## **SERVICE BULLETIN SB0009**

SUBJECT: FRONT LAP BELT FLOOR MOUNTING BOLTS

MODELS AFFECTED: CC18-180A SERIAL NUMBER 0001

FIGURE 1 -Pilot Right Side Lap Belt Attachment, Lock Nut (Head of Bolt Facing Aircraft Centerline)

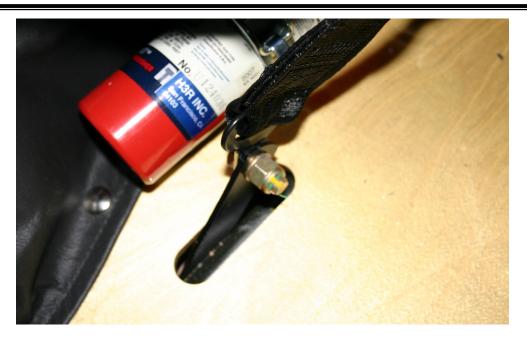
**PURPOSE:** Cub Crafters, Inc. has determined that the front seat lap belt

mounting bolts and lock nuts may be tightened such that the belt does not pivot and conform properly to the occupant. This Service Bulletin requires that the hardware be changed to a castle nut and cotter pin such that the belt is allowed to pivot

- 1. Remove the existing front seat lap belt hardware as shown in Figure 1.
- 2. Install new hardware with the nuts toward the aircraft centerline (this provides better foot clearance and prevents snagging on the cotter pin). Reference Figure 2. Install the hardware finger tight and back off to the nearest castellation for cotter pin insertion. The belt mount should rotate with as little play as possible.

<u>PART</u>	DESCRIPTION	QTY
AN6-7	BOLT	2
AN310-6	NUT	2
AN380-3-3	COTTER PIN	2
AN960-616	WASHER	4
